# Service Bulletin

Bulletin No.: 18-NA-346

**Subject: Vehicle Will Not Start and/or Service Electronic Steering Column Lock System Message Displayed on Driver Information Center (DIC)**

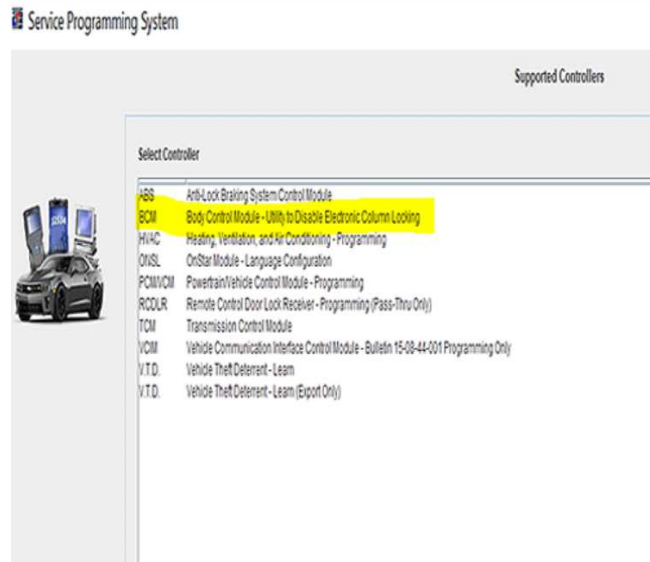
Replace the steering column lock plate (1) with the new plate (2), and update the BCM with the new utility file.
